**SKA Signal Processing
Concept Design Review
(SP CoDR)**

14th to 15th April 2011

Report of the Review Panel

Figure 1

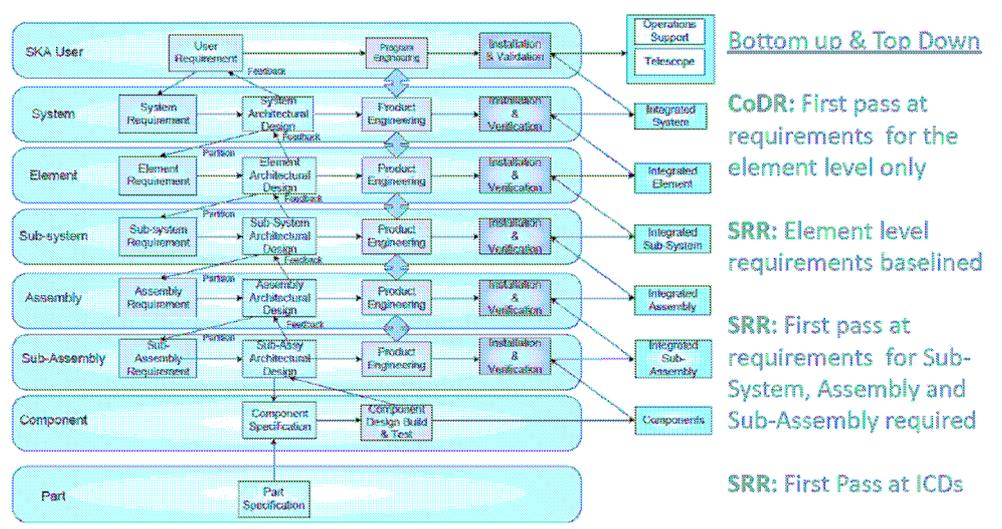
Figure 1, which was presented, indicates feedback from the Element architecture level to the System architecture. The Panel was left unsure of how this was going to be accomplished. This would be easier if a clearer definition of each of the available architectures could be established.

Recommendation 1: The Project should clearly define a number of suitable architectures to be investigated further in the next phase. These will probably align with options to be carried forward into the next phase. Each of these architectures may have different impact at the system level, and these impacts should be carefully examined at both levels.

Figure 2

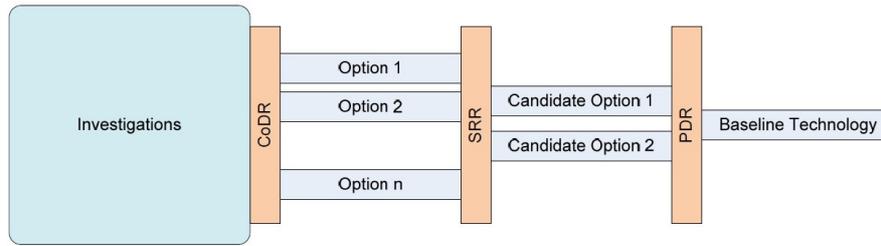
As shown in the Figure 2, the Project plans to take forwards a number of potential solutions to the Signal Processing Sub-System Requirements Review (SP-SRR) milestone and make a decision at that point on a reduced set of Candidate Options. The date scheduled for the SRR is Q3 2012, which provides about 15 months for the further development and optimisation. Also, the System Requirements Review (SRR) will be held in early 2012. There is likely to be significant feedback to the system level from the Signal Processing Element level, which could influence the SRR. It will be important that this feedback be based on clearly defined options.

The Panel was concerned that carrying forward too many options could be wasteful of resources and hence counter productive. The Panel felt that it would be desirable to focus the number of options as early as possible and that this could perhaps be achieved through encouraging collaborations that would allow merging some of the options.

The means by which decisions on options will be made is unclear at this point. It is reasonable to expect such decisions to be made on the basis of performance requirements, as well as on cost.

Recommendation 5: There are about 200 requirements currently defined for the Signal Processing functions. The Panel felt that this was too many to handle for the selection process and recommended that the Project should define a small subset of the key requirements and evaluation criteria, perhaps 10 to 12 or so, against which the different architectural approaches can be compared. This subset should probably contain factors like cost (NRE, variable and running), power consumption, technical performance (S/N, pulsars/min.), flexibility, reliability, fault tolerance, and future proofness. The ability of an approach to exploit factors such as parallelism and locality should also be considered (see appendix I).
